Project	IEEE 802.16 Broadband Wireless Access Working Group < http://ieee802.org/16 >	
Title	A method of scanning neighbor BSs periodically	
Date Submitted	2004-06-07	
Source(s)	Kihyoung Cho, Yongho Kim LG Electronics, Inc. 533, Hogue-1dong, Dongan-gu, Anyang-shi, Kyongki-do, Korea	Voice: 82-31-450-2945 Fax: 82-31-450-7912 [mailto: kihyoung@lge.com, ronnykim@lge.com]
Re:	This is a response to a Call for Comments IEEE802.16e Handover Adhoc.	
Abstract	In this contribution, a method of supporting periodic scanning is provided.	
Purpose	This document is submitted for review by 802.16e Working Group members	
Notice	This document has been prepared to assist IEEE 802.16. It is offered as a basis for discussion and is not binding on the contributing individual(s) or organization(s). The material in this document is subject to change in form and content after further study. The contributor(s) reserve(s) the right to add, amend or withdraw material contained herein.

A method of scanning neighbor BSs periodically

Figure E.1—Example BS advertisement and scanning (without association) by MSS request

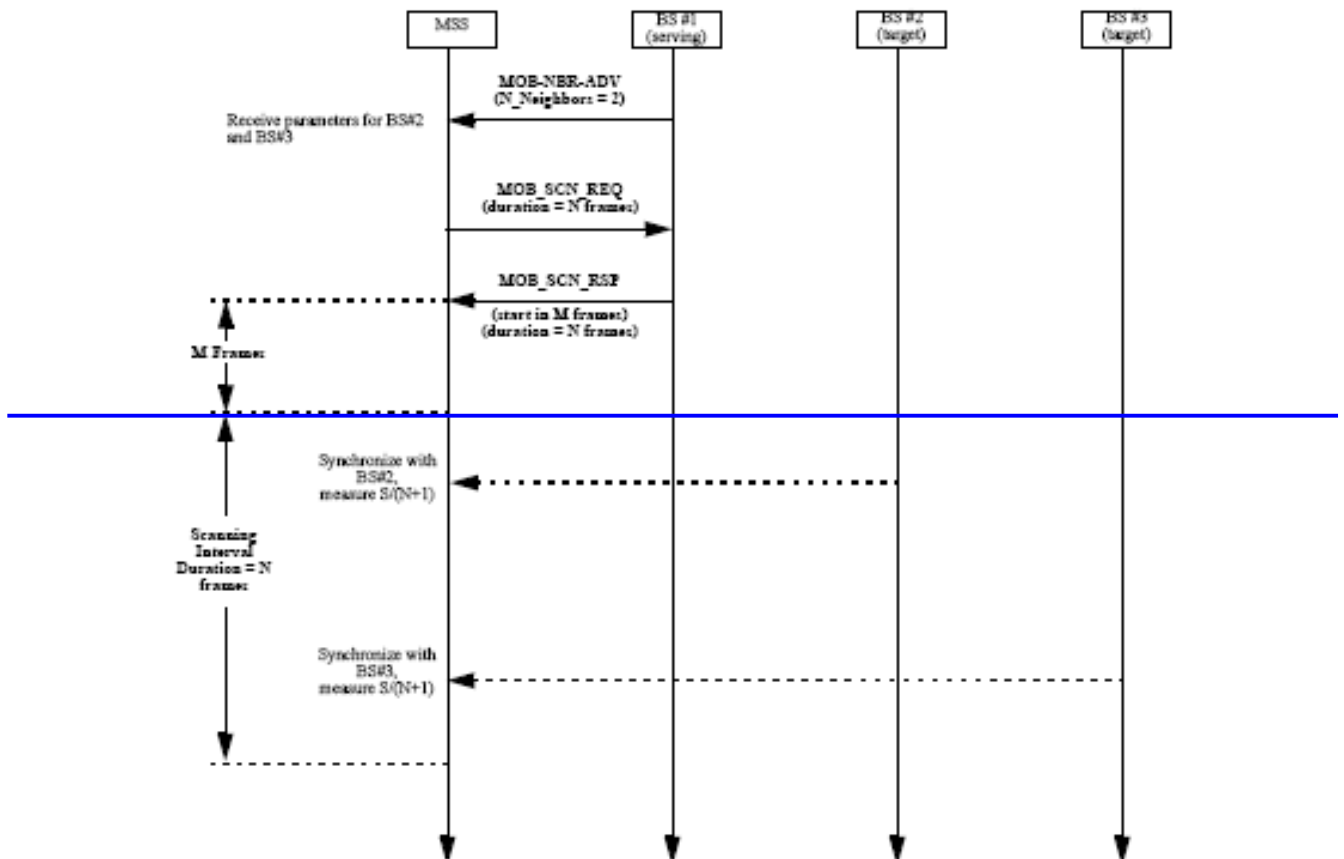
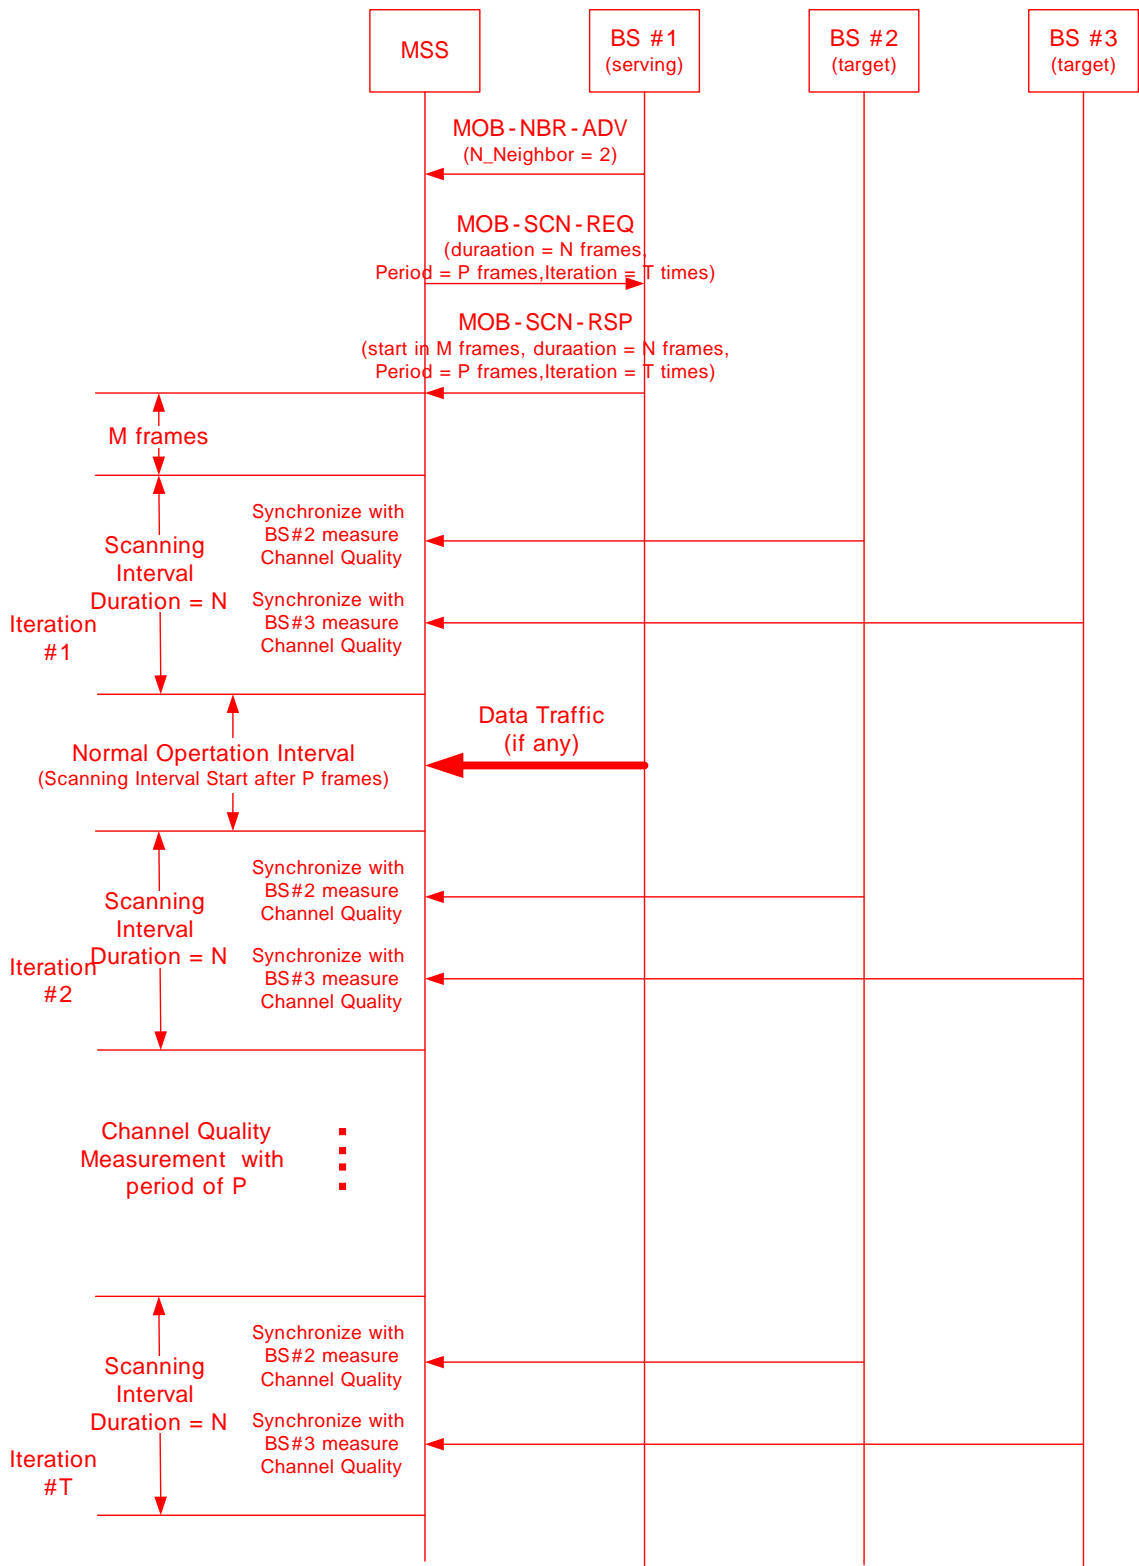
[Modify the Figure E.1– Example BS advertisement and scanning (without association) by MSS request]

The following figures describes the messages flow for neighbors advertisement and scanning of neighbors by the MSS request, BS request and periodic scanning of neighbors during hand-over.
